Development Review Committee Staff Report

Case No:	16DEVPLAN1039
Project Name:	Calvary Christian Church Parking Lot Expansion
Location:	10710 Taylorsville Road
Owner(s):	Calvary Christian Center
Applicant:	Owner
Representative:	Civil Design. Inc.
Project Area/Size:	8.8 acres
Jurisdiction:	Louisville Metro/ Jeffersontown
Council District:	20 – Stuart Benson
Case Manager:	Sherie' Long, Landscape Architect

Waiver #1: LBA Screen Plantings

Waiver #2: Easement Encroachment into LBA

Attachment 3: Concept Landscape Plan

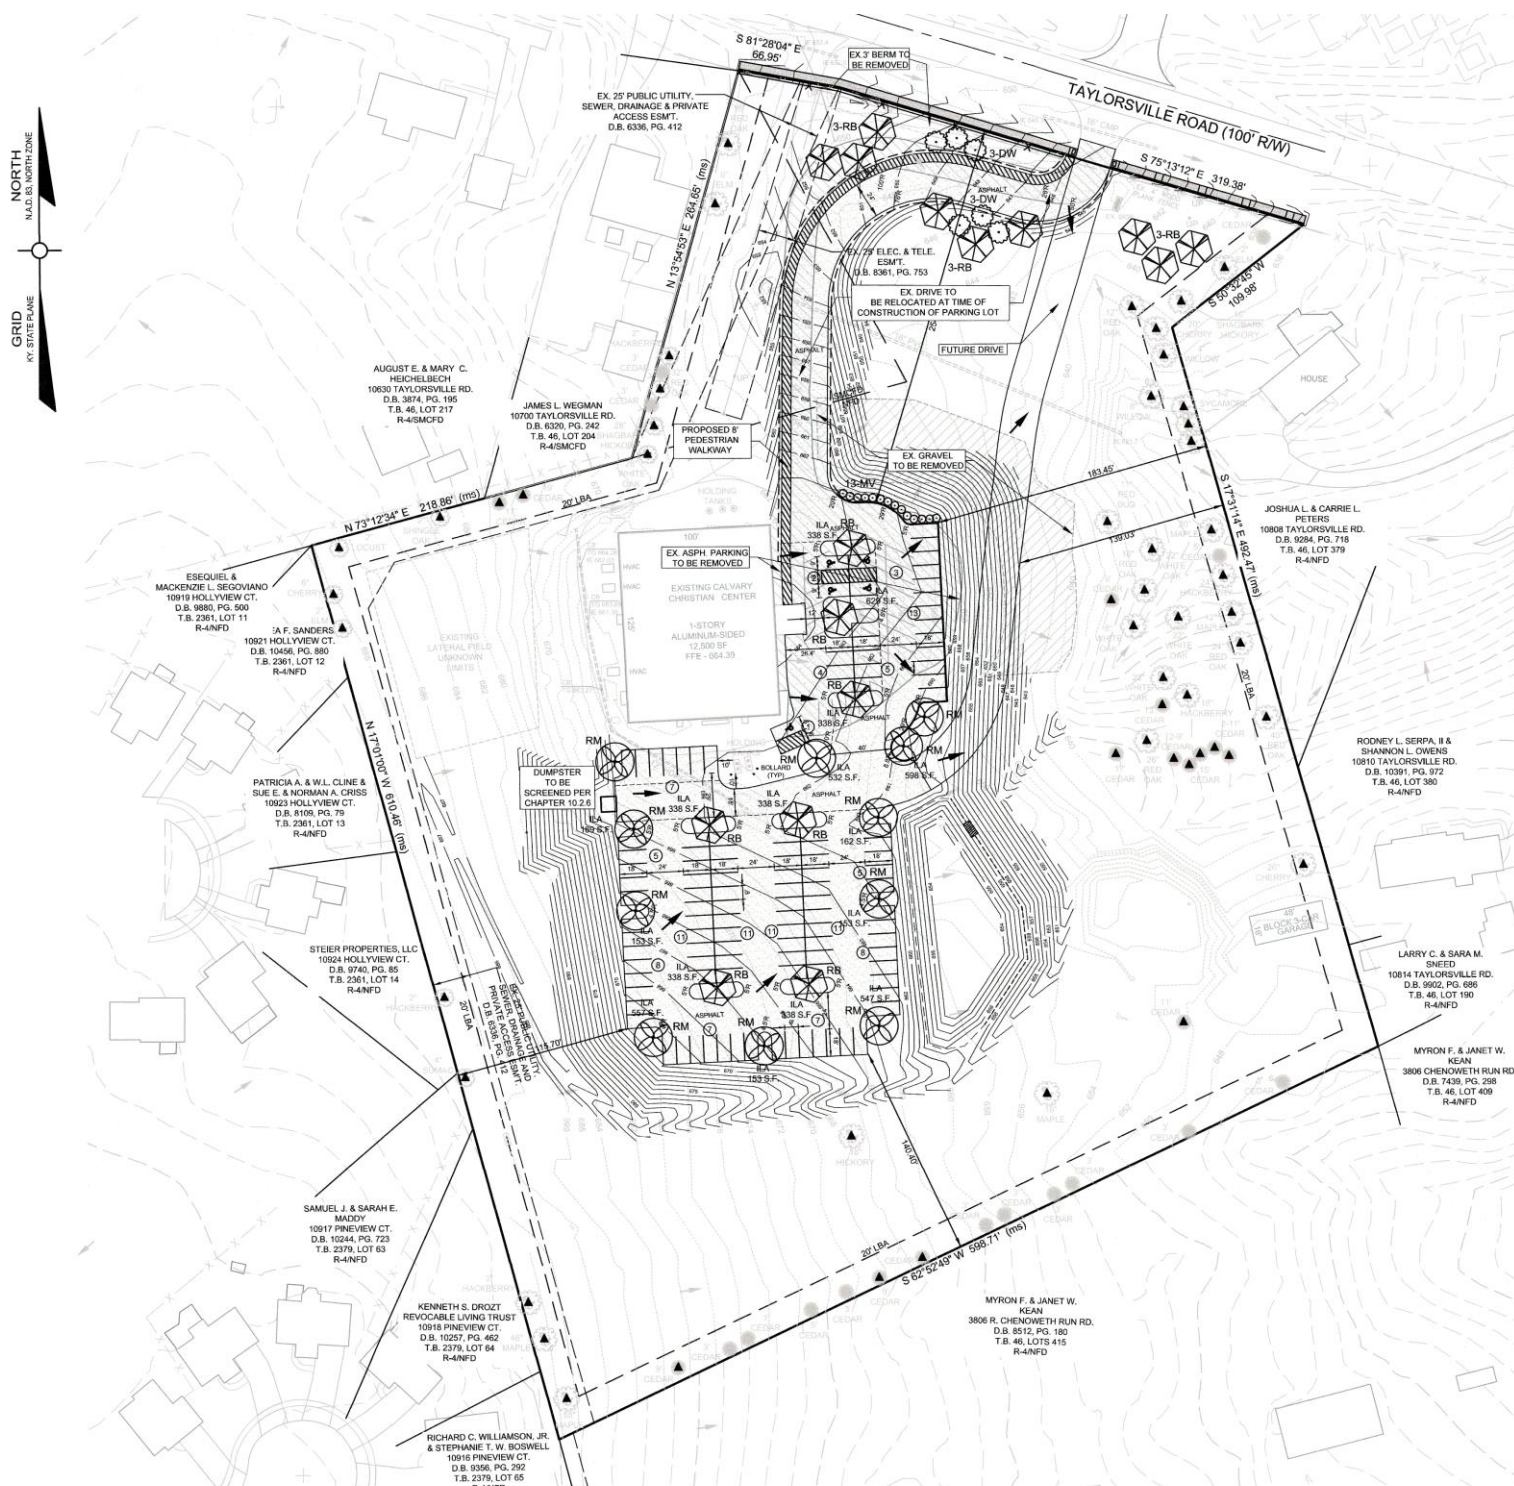
STAFF: The waiver will not adversely affect adjacent property owners since the existing perimeter vegetation including all the large trees will be preserved to screen the development from the adjacent residential property. Plus the distance of the parking from the perimeter is between 100 and 200 feet. In addition, the building and parking are 18' lower than the residential property to the west. All three perimeters have sufficient existing vegetation screening the property from the residential uses. .

STAFF: The extent of the waiver of the regulation is the minimum necessary to afford relief to the applicant since the applicant is requesting to not provide the 6' screen but instead preserve the existing vegetation.

STAFF: The applicant has provided plantings in excess of the minimum requirements. Additional trees are being provided on site along the street frontage and in the interior of the proposed parking lot. Plus all the perimeter existing vegetation is being preserved.

STAFF: The waiver will not adversely affect adjacent property owners since the required plantings are being provided in the area of encroachment by preserving the existing vegetation and also planting new trees.

STAFF: The extent of the waiver of the regulation is the minimum necessary to afford relief to the applicant since the buffer and planting requirements will be provided even with the encroachment.

STAFF: The applicant has provided plantings which exceed the minimum required along all perimeters and within the parking area interior, therefore a net beneficial effect.

Considering the applicant is exceeding the minimum planting requirements along the perimeter by preserving the existing healthy trees; and also providing new tree and shrub plantings which exceed the minimum street frontage and interior planting requirements both of the requested waivers are supported.
